Amendment, Permit # B17002901

I am requesting to amend Permit # B17002901 at
12245 RUNNING FENCE LANE CLARKSVILLE to
ADDING FULL BATH UNDER ~~EXISTING~~ EXISTING DECK
FOR POOL USE

Amendment Letter

MISTRY RESIDENCE
12245 RUNNING FENCE LANE

WALNUT GROVE
LOT 27

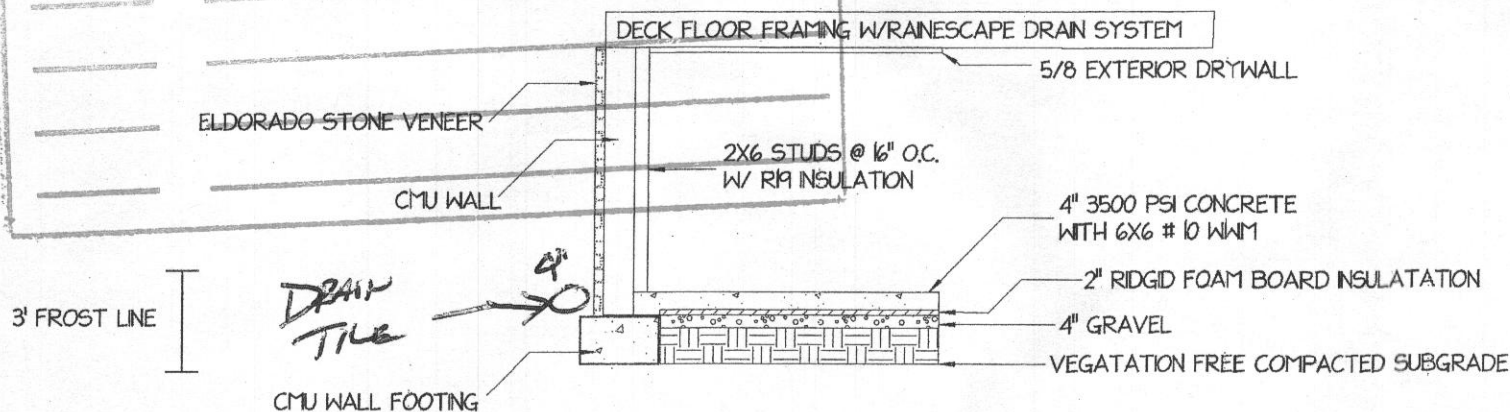
ADD FB under deck

WALL SECTION

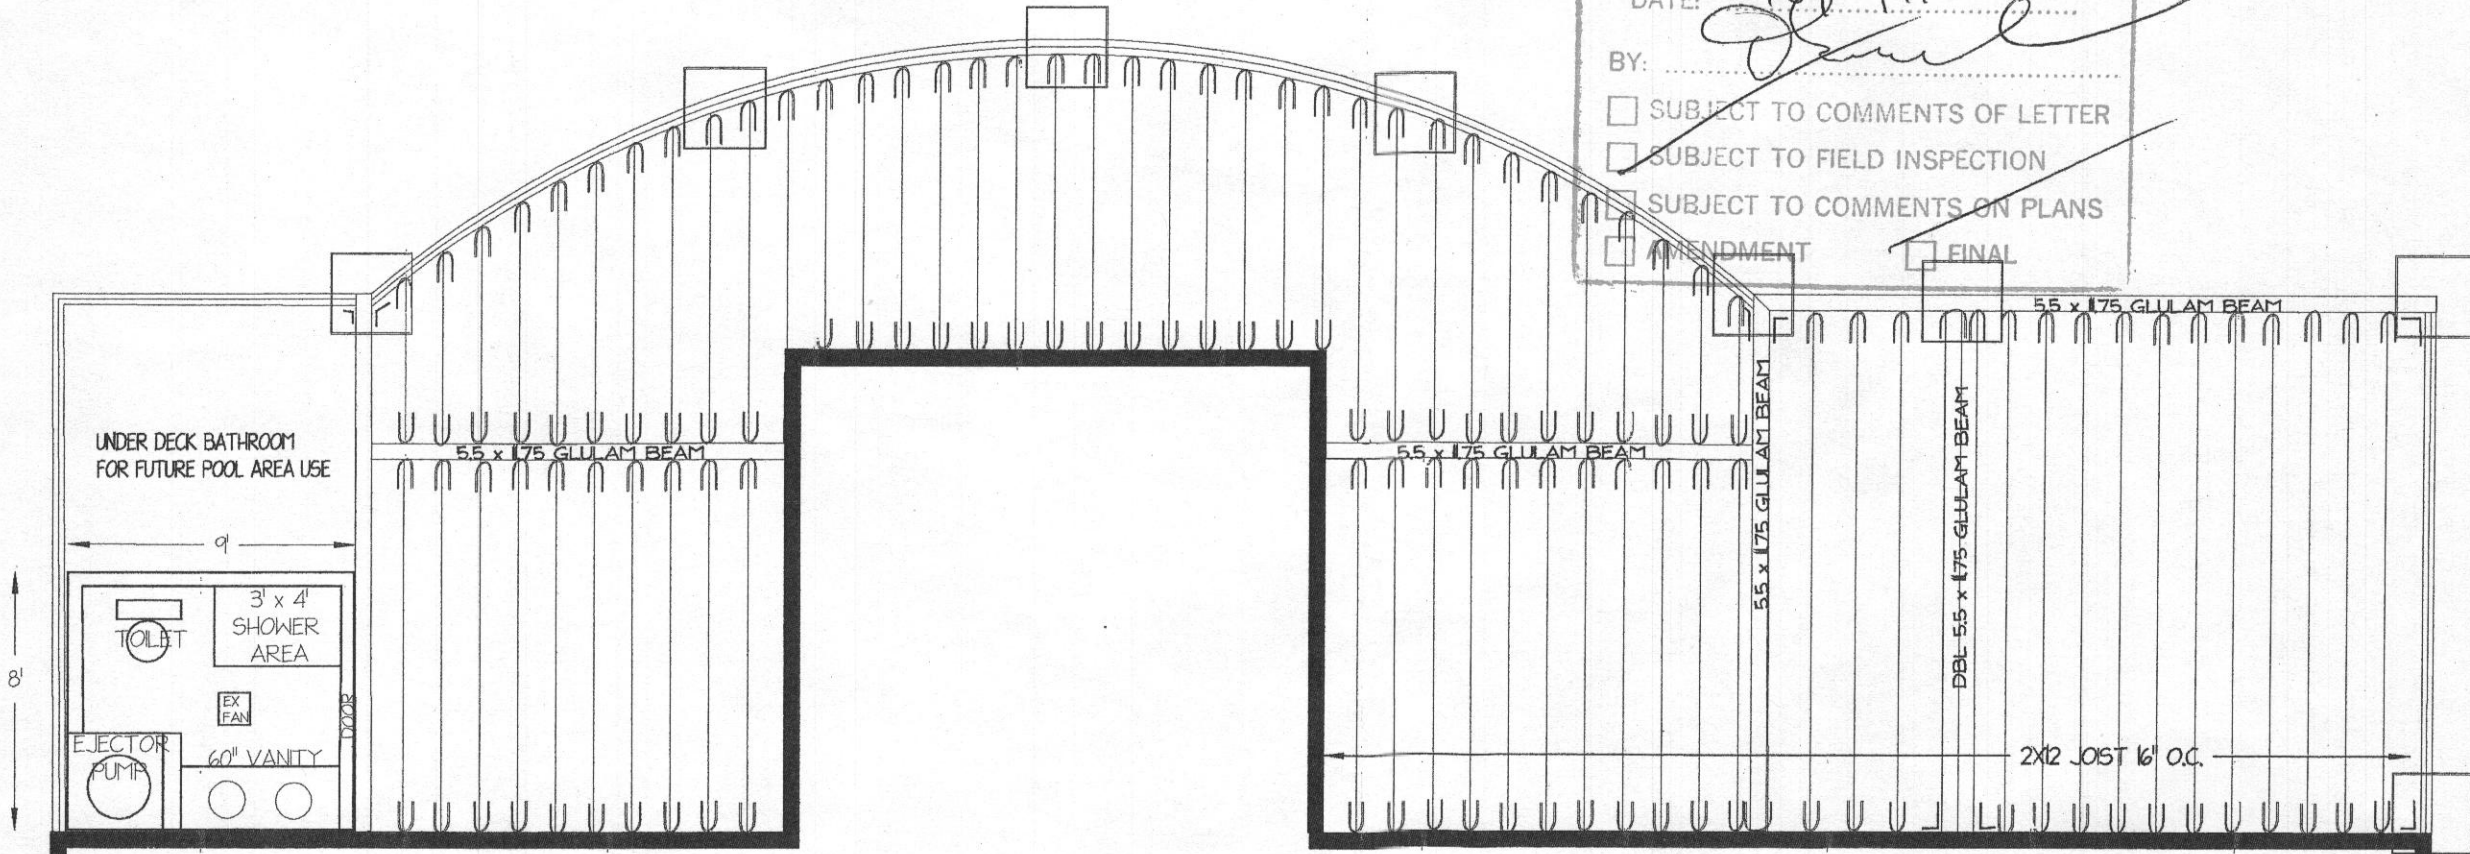
Any additions, alterations, or repairs that require a building permit shall be provided with smoke alarms as required for new dwellings.
